Planning Commission Staff Report

Subject: Treasure
Project #: PL-08-00370
Authors: Francisco Astorga, AICP, Senior Planner
Date: 25 October 2017
Type of Item: Administrative – Conditional Use Permit
Refinement 17.2 Update

CREOLE SITE SAMPLE ELEVATIONS
 SWEENEY PROPERTIES MASTER PLAN

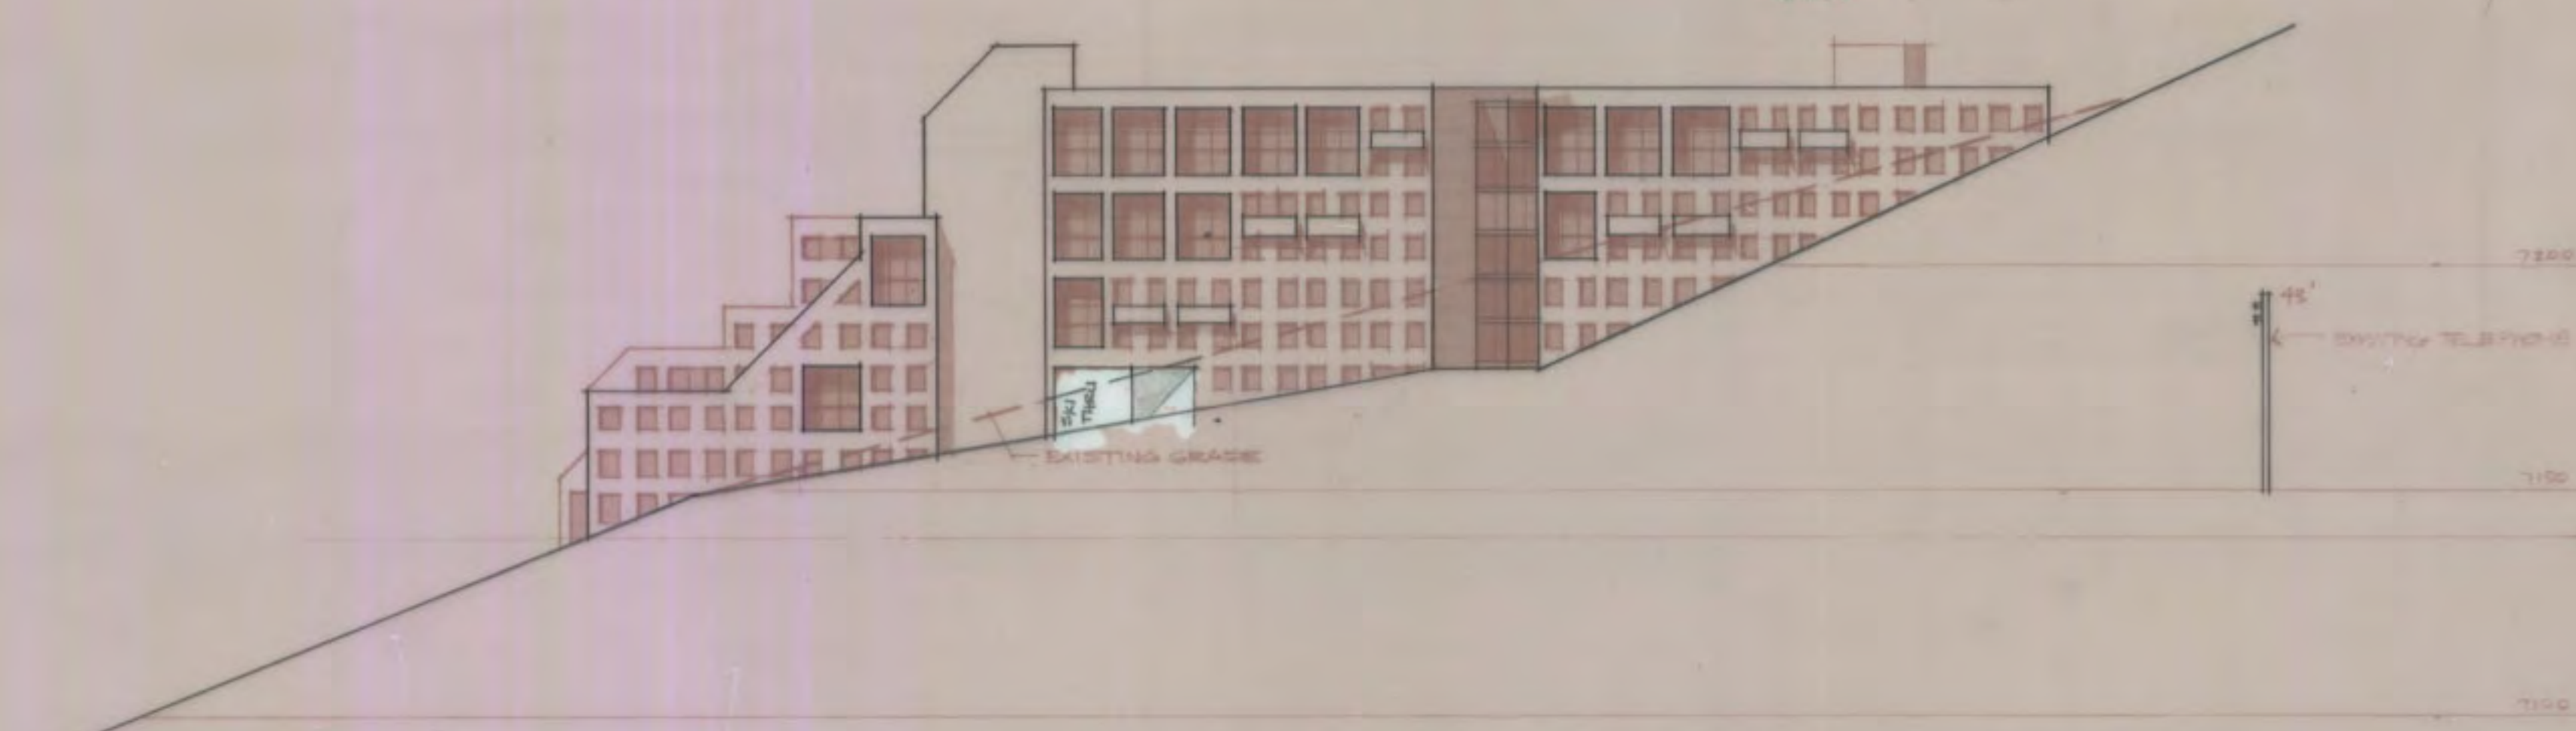
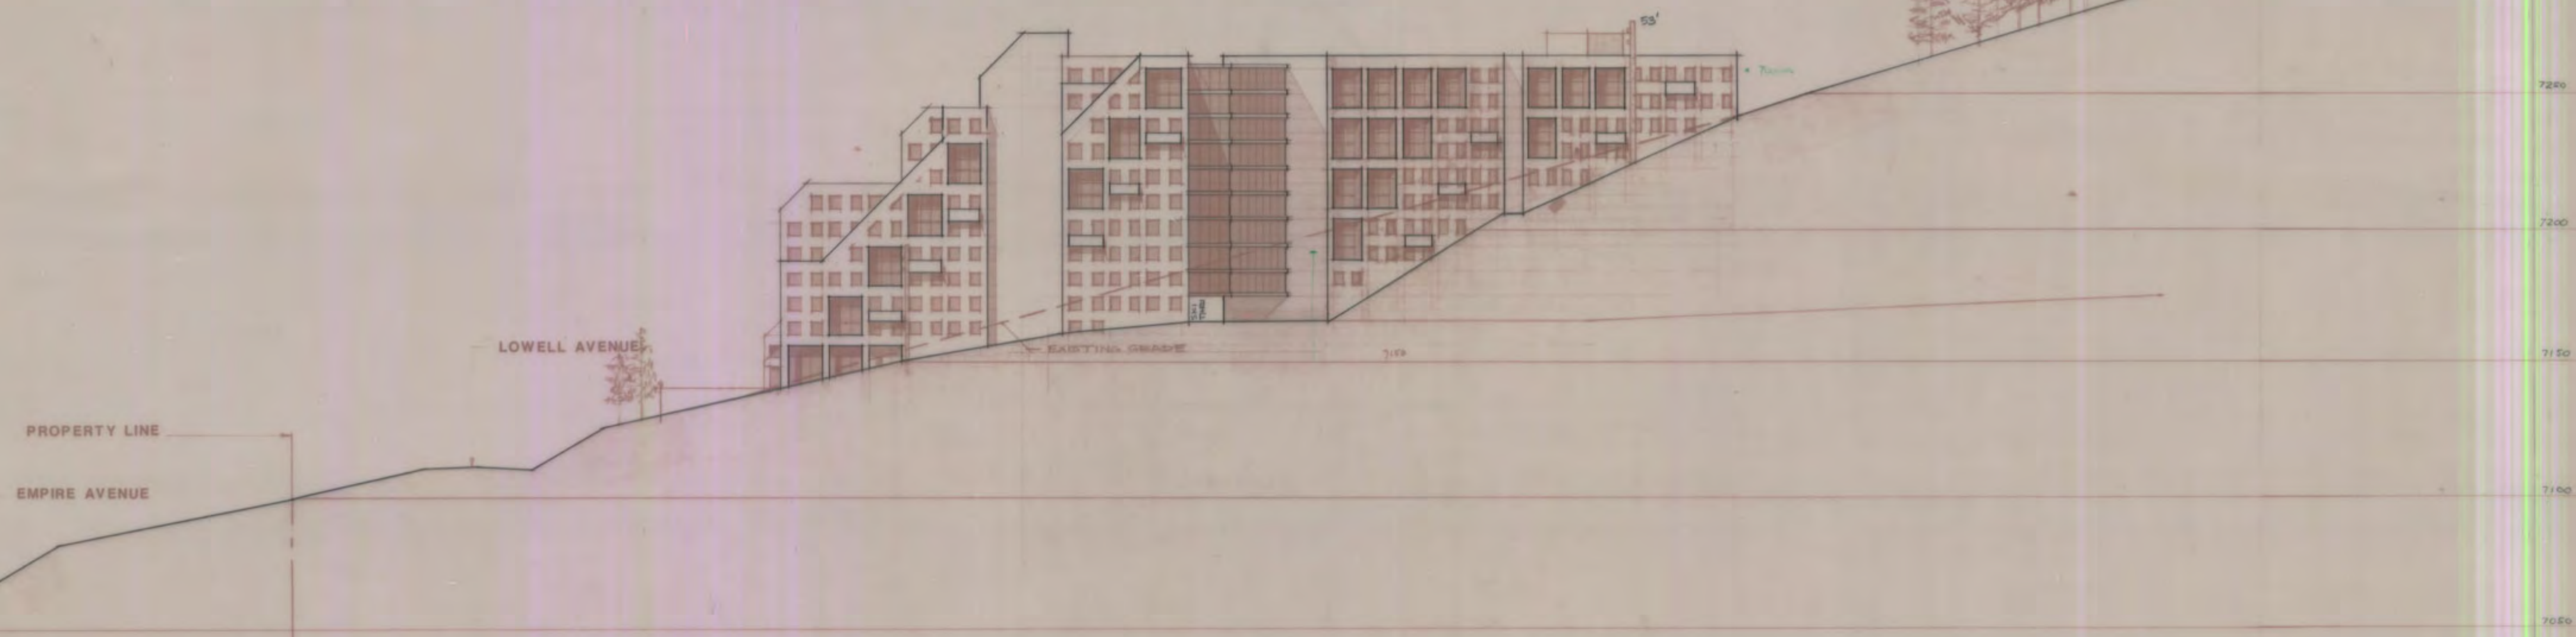
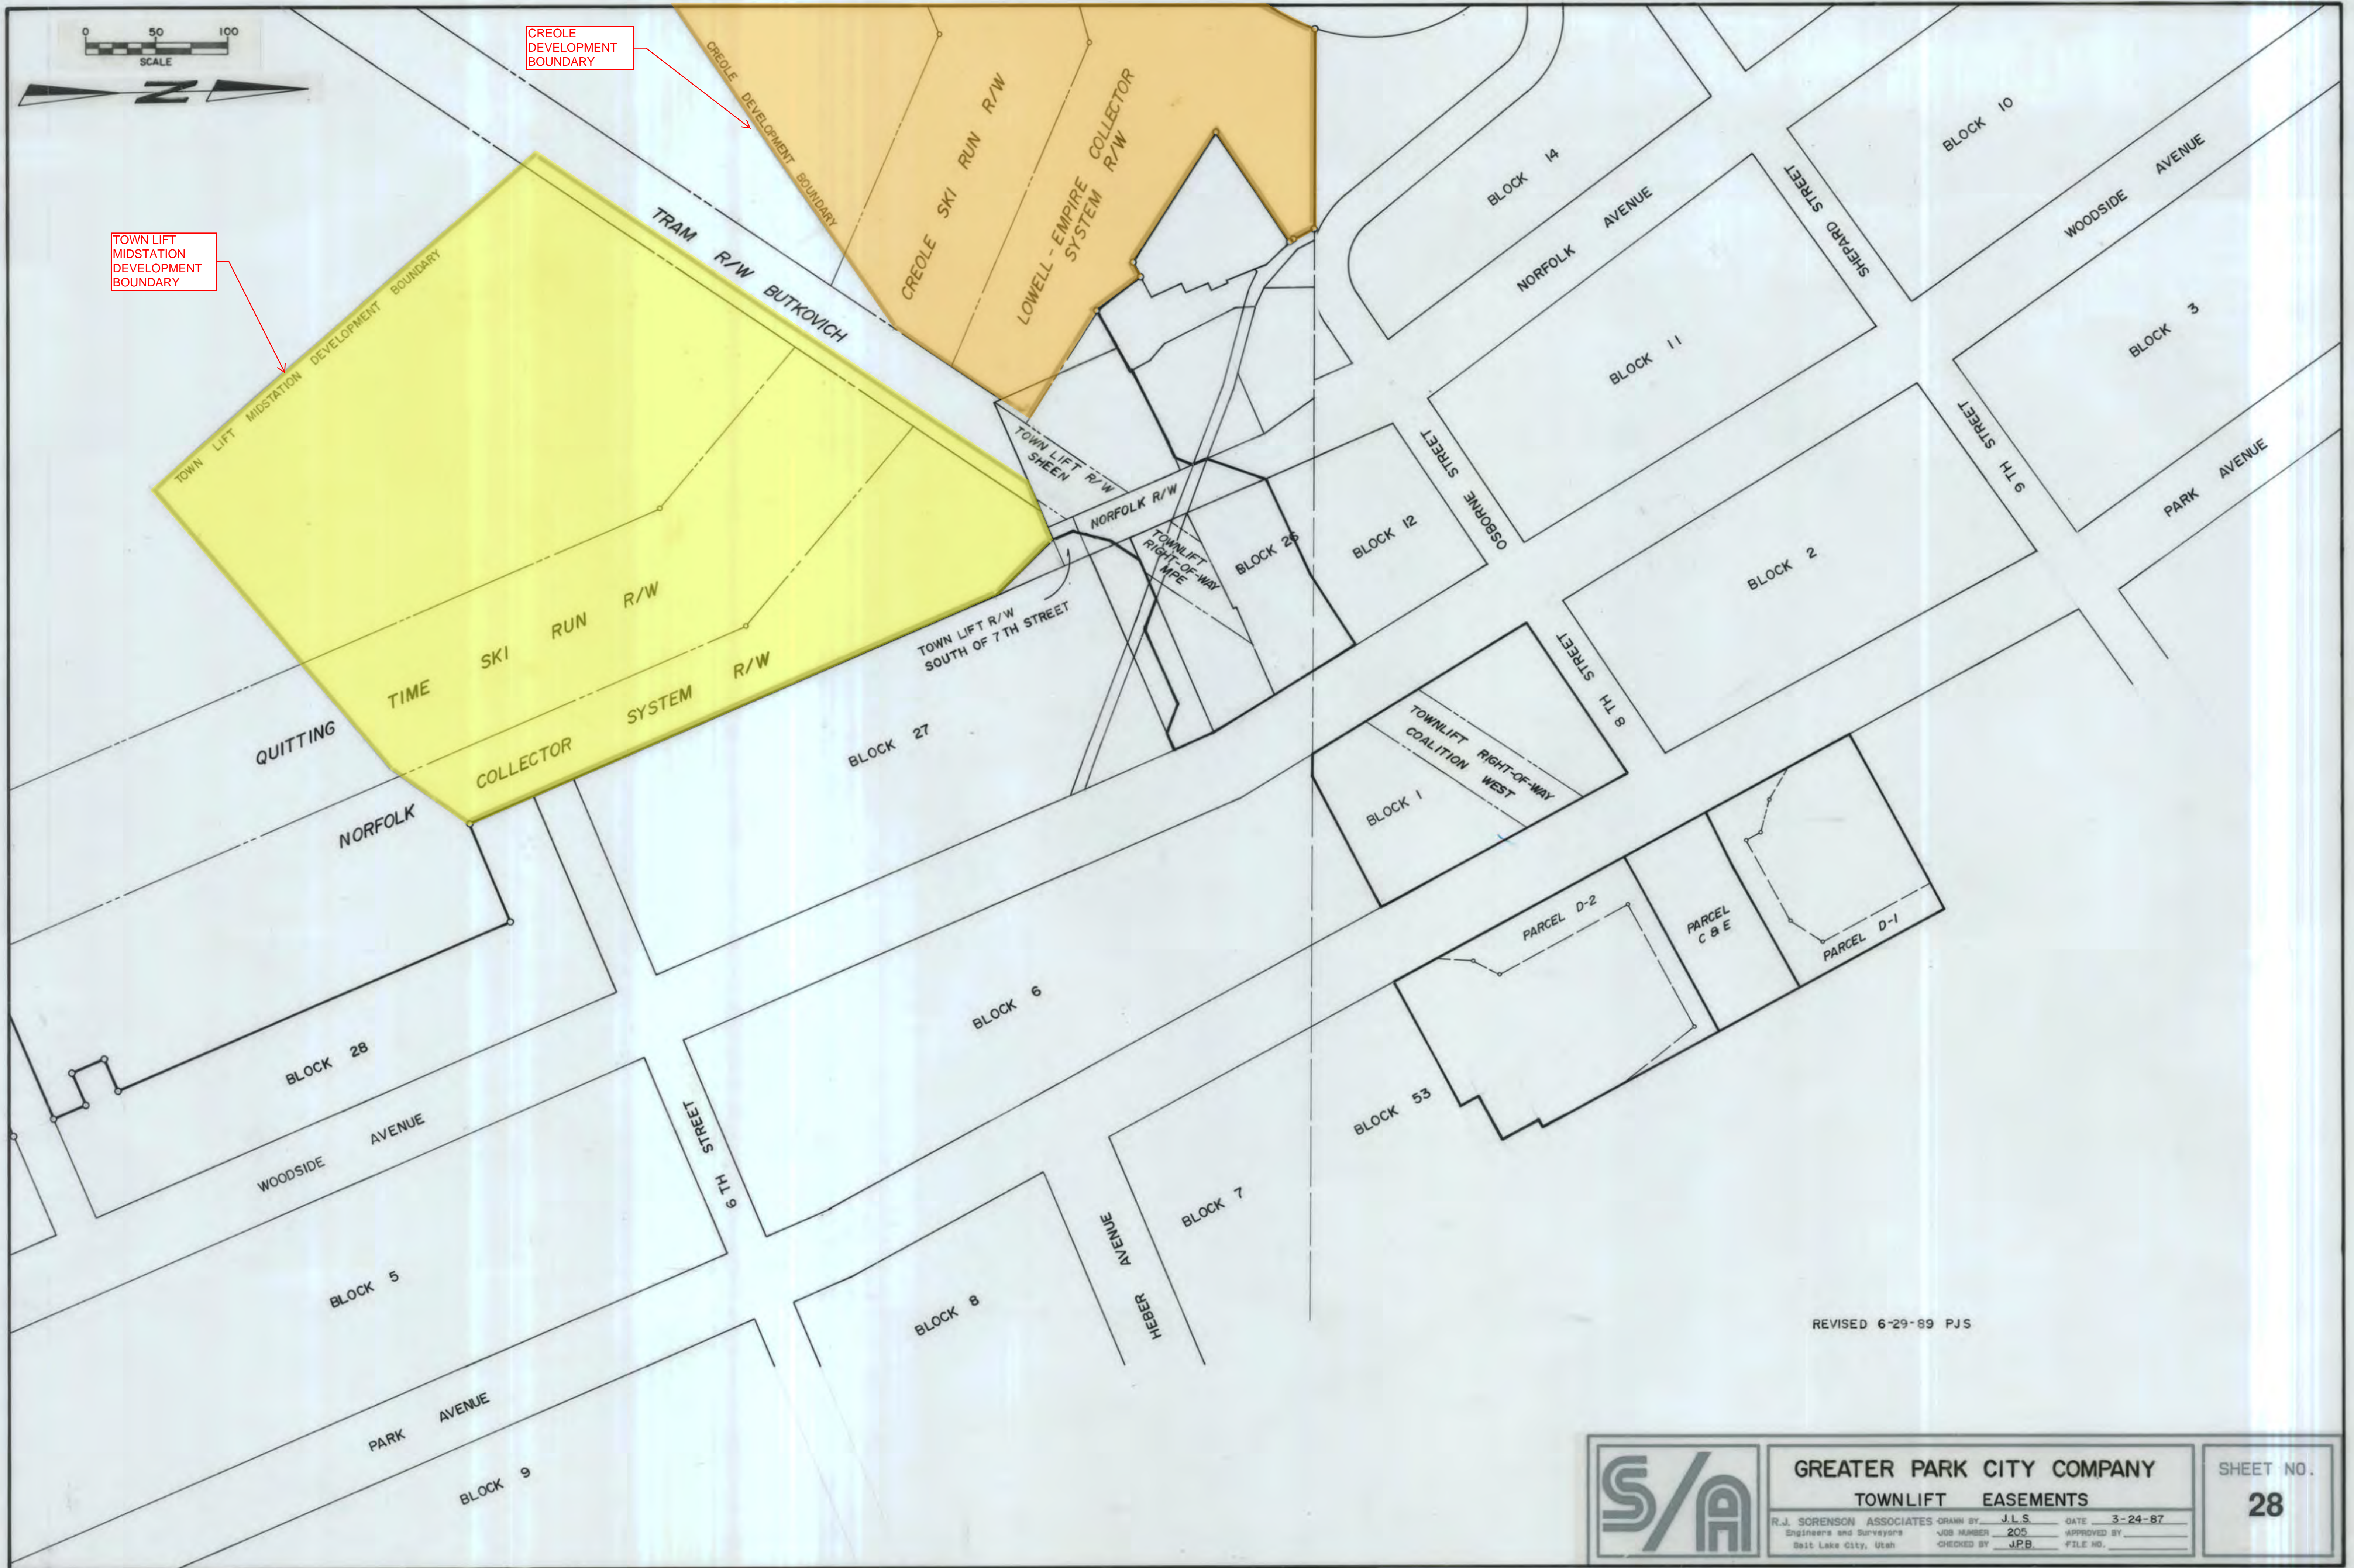
22. Building C, D, and E elevations show re-grading existing grade as final grade is shown around the periphery of the building.
23. Building C existing grade is taken down approximately 24 feet towards the middle of the building at the periphery of the structure; see sheet 24.

24. Building D existing grade is taken down approximately 35 feet towards the middle of the building at the periphery of the structure; see sheet 24.
25. Building E existing grade is taken down approximately 25 feet towards the middle of the building at the periphery of the structure; see sheet 24.

26. Building C, D, and E start at existing grade, drop down towards the middle of each building as indicated above, and then final grade catches up to existing grade towards the back of each building.

ELEVATION BUILDING D AND SITE SECTION

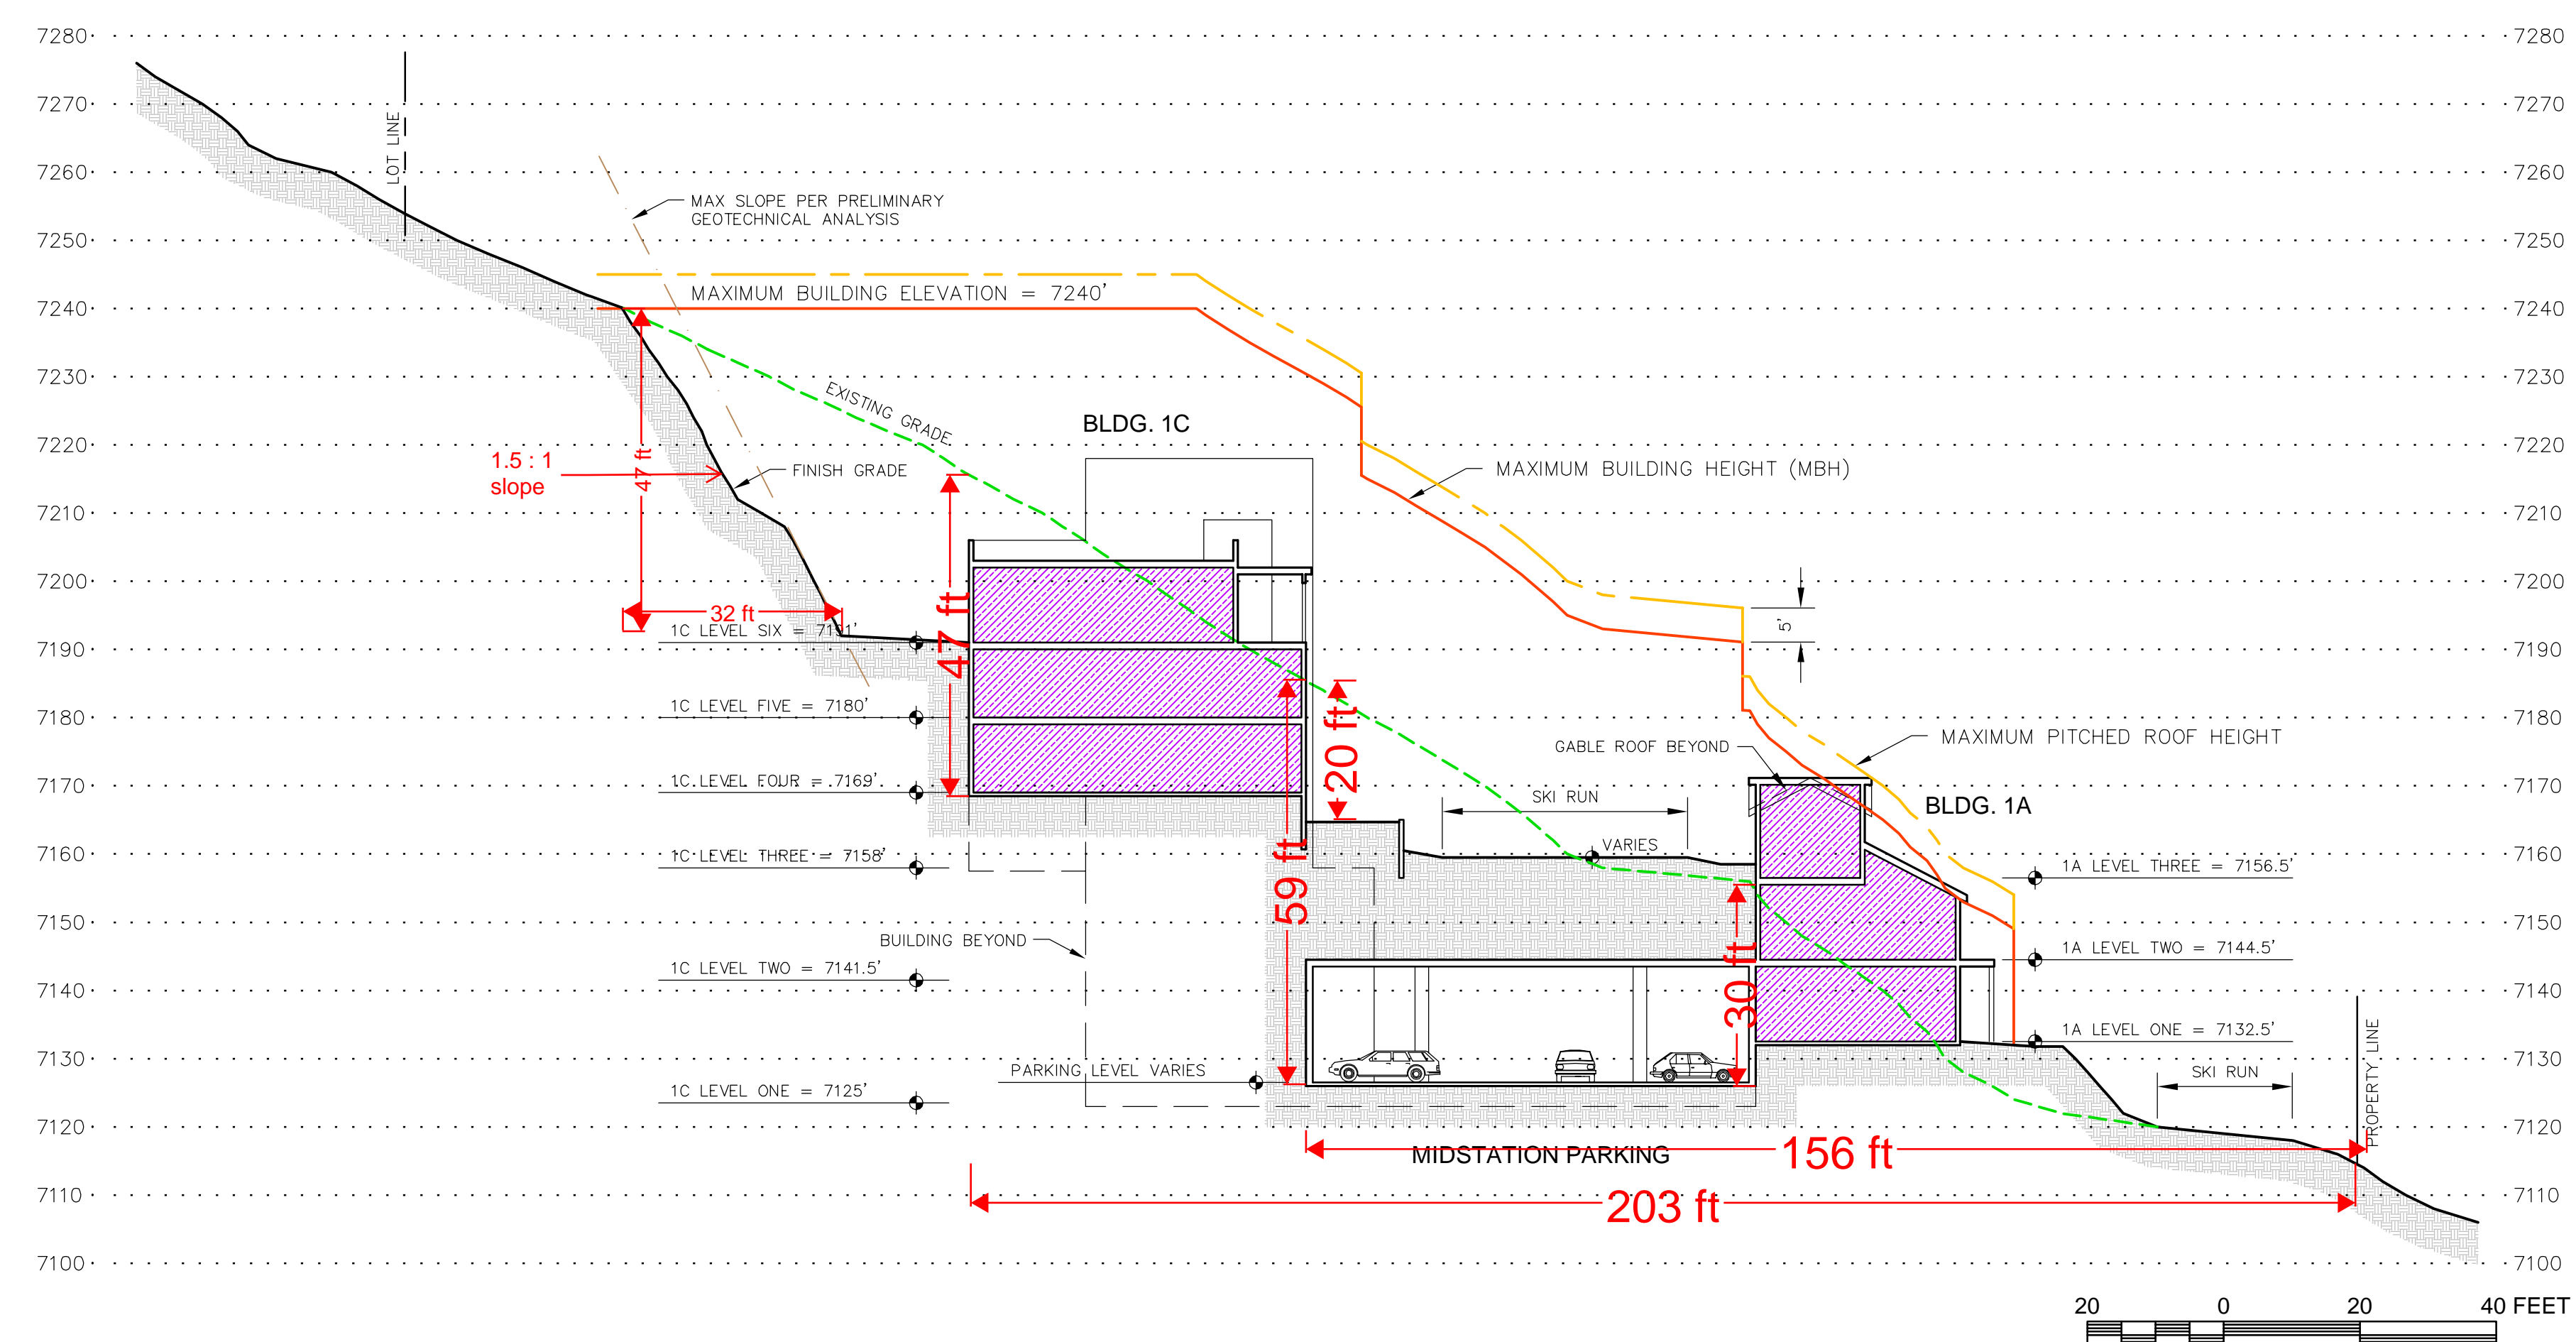
27. Sample elevation C and E show compliance with the building sections/height zone plan, measured from existing grade. Sample elevation D was not updated/amended to show the adopted height as the change is indeed reflected on the building section sheet 17 and height zone plan sheet 22.
28. Sheet 28 and 29 show each ski run bi-furcating its corresponding site as well as the development boundaries.

TOP OF BUILDING NOT UPDATED TO REFLECT APPROPRIATE HEIGHT AS CHANGED & SHOWN ON BLDG. SECTION D ON SHEET 18 OR REFLECTED ON HEIGHT ZONES SHEET 22
